Re: Central Hudson Gas & Electric Corporation  
Newburgh Former Manufactured Gas Plant, Newburgh, New York  
Order on Consent, Index #D3-0001-95-06, dated October 1995  
BBL Project #: 0205.20537 #5

*Areas B and C Pre-Design  
Investigation Work Plan  
Addendum*

**Central Hudson Gas & Electric Corporation  
Newburgh, New York**

**October 2006**

**AREA B PRE-DESIGN INVESTIGATION  
 LOCATIONS**

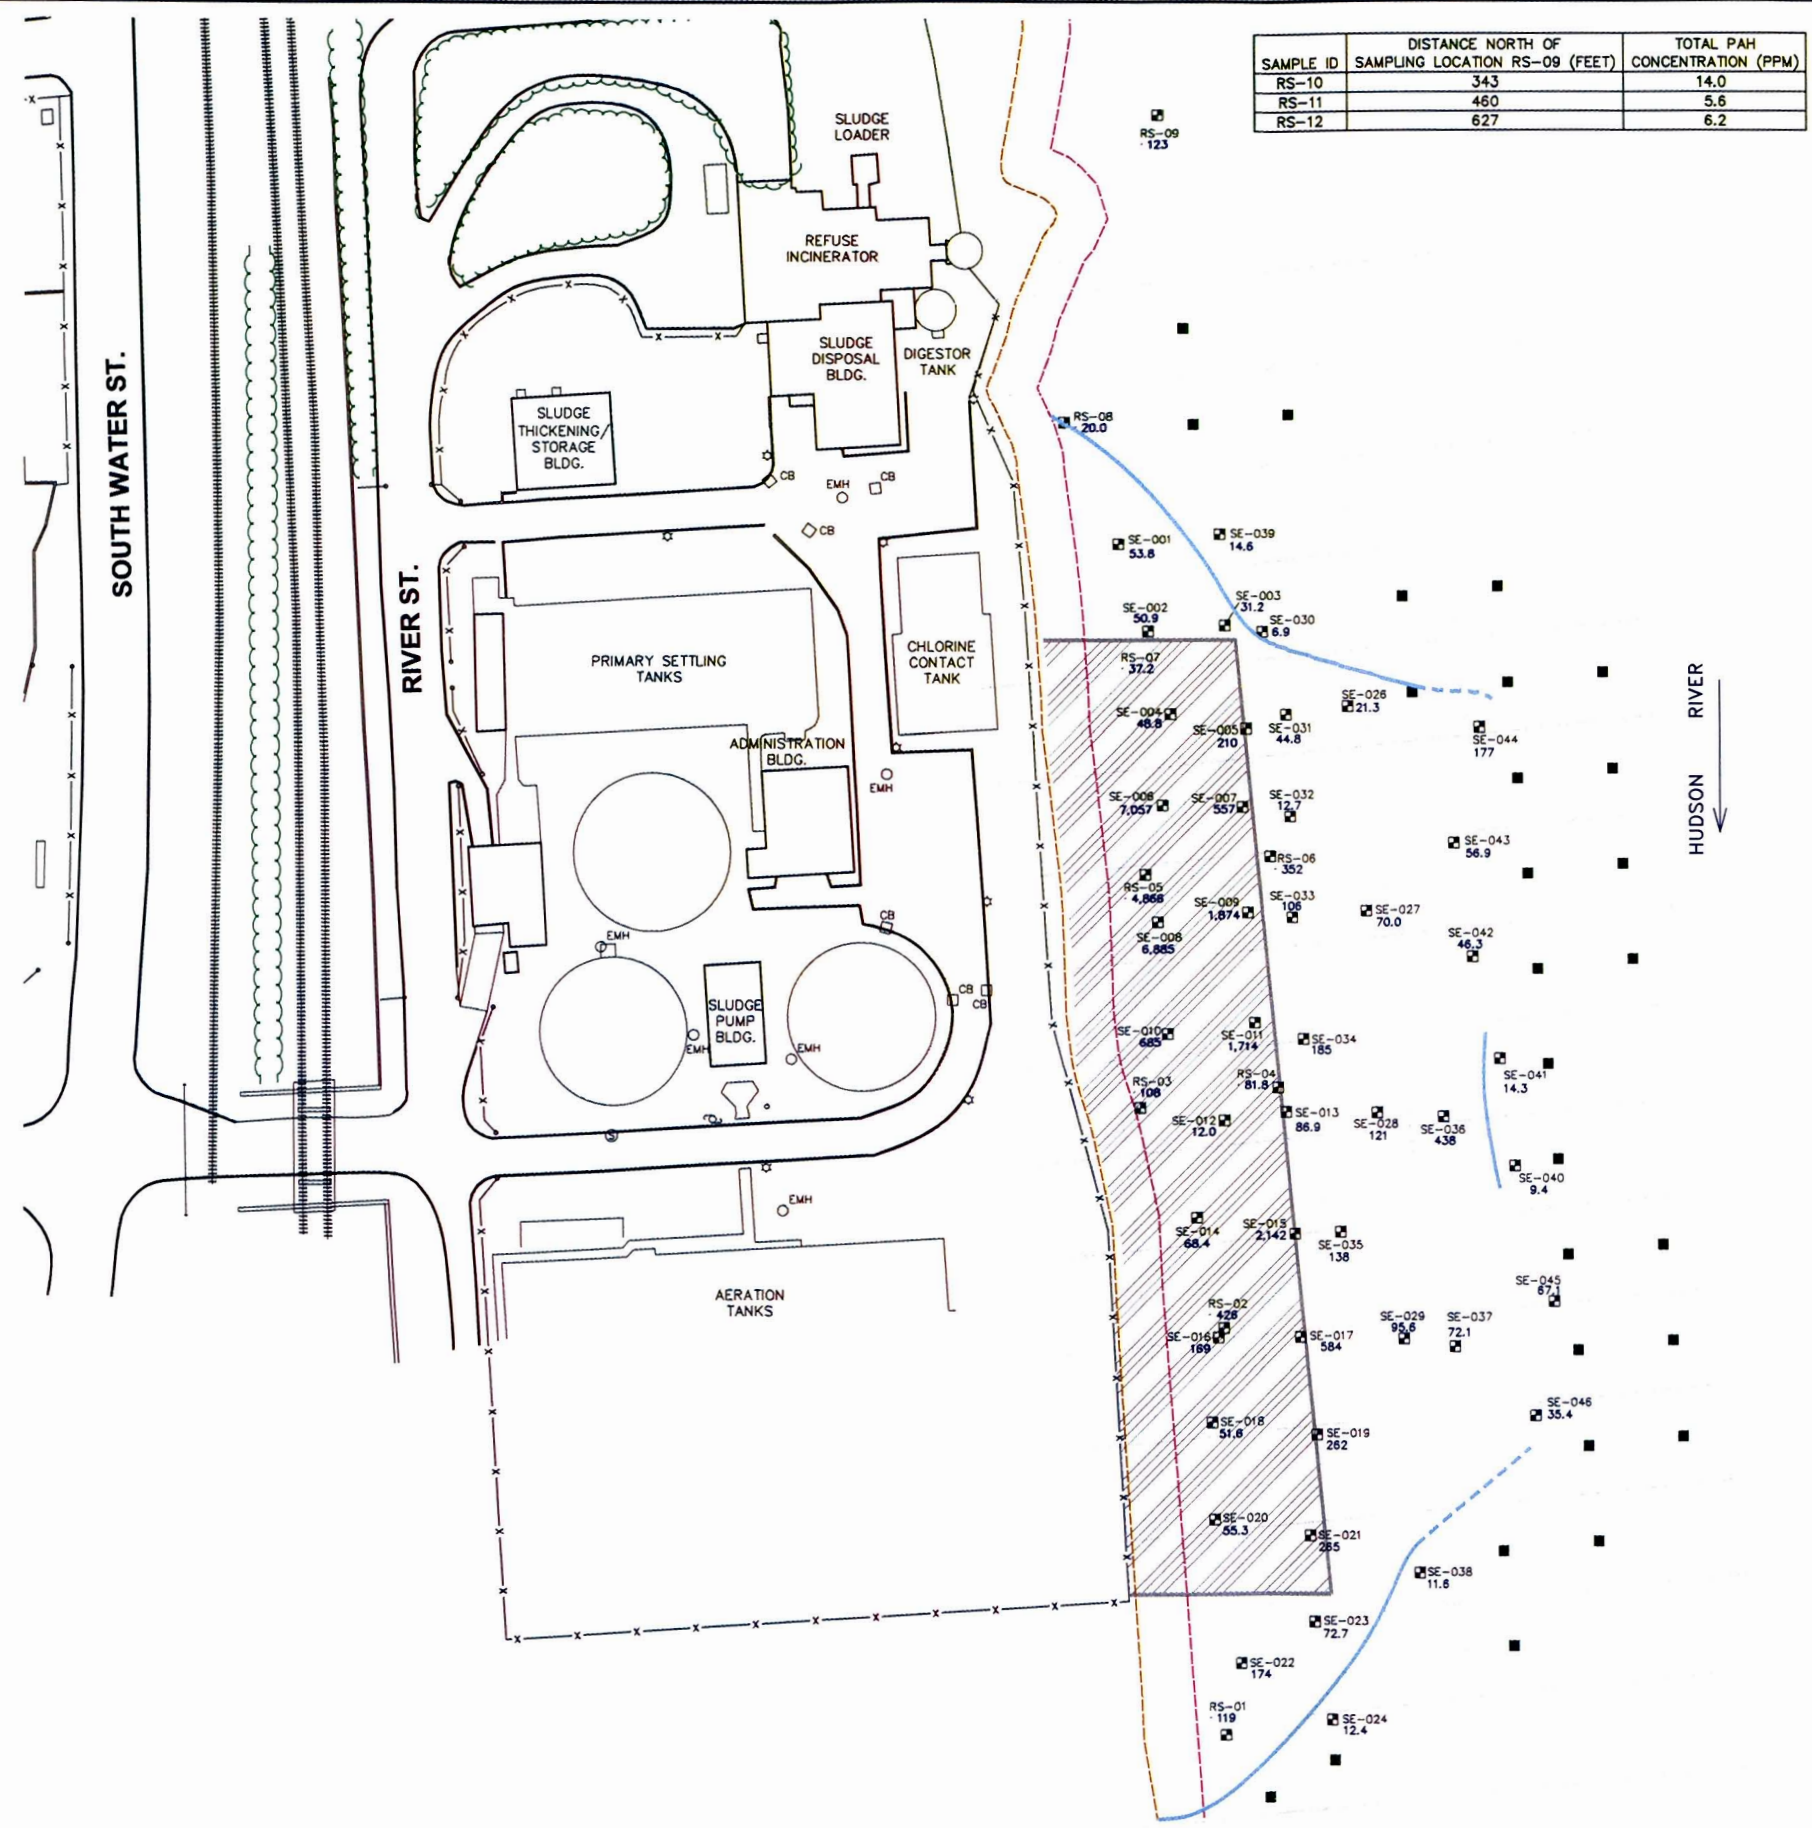
Up to five additional TarGOST borings will be completed to identify the potential presence of NAPL adjacent to the northern portion of the NAPL barrier wall area. Sampling will be performed in accordance with protocols previously set forth in the Work Plan. The proposed additional probing locations are located in Area B, adjacent to the chlorine contact tank and north to previous soil boring TB-29 as shown on Figure 1.

The findings of the TarGOST probing will be confirmed with soil boring using direct push technology (DPT) at a minimum of 25% of the probing locations. The intent of these confirmation locations is primarily to verify the presence of NAPL where indicated by the TarGOST probing. Further, these confirmation borings will be preferentially selected based on the following:

- areas where less borings were completed during RI (i.e. north of chlorine tank and near the proposed STP aeration tank expansion); and
- areas where the NAPL distribution based on the TarGOST probing efforts appears to be different than the NAPL distribution as delineated based on the approximately 20 borings and wells completed between former Renwick Street and the chlorine contact tank along the river.

As such, DPT confirmation borings will be completed at a minimum of 25% and up to 50% of the TarGOST probing locations (as appropriate) to verify the presence and location of NAPL in the subsurface.
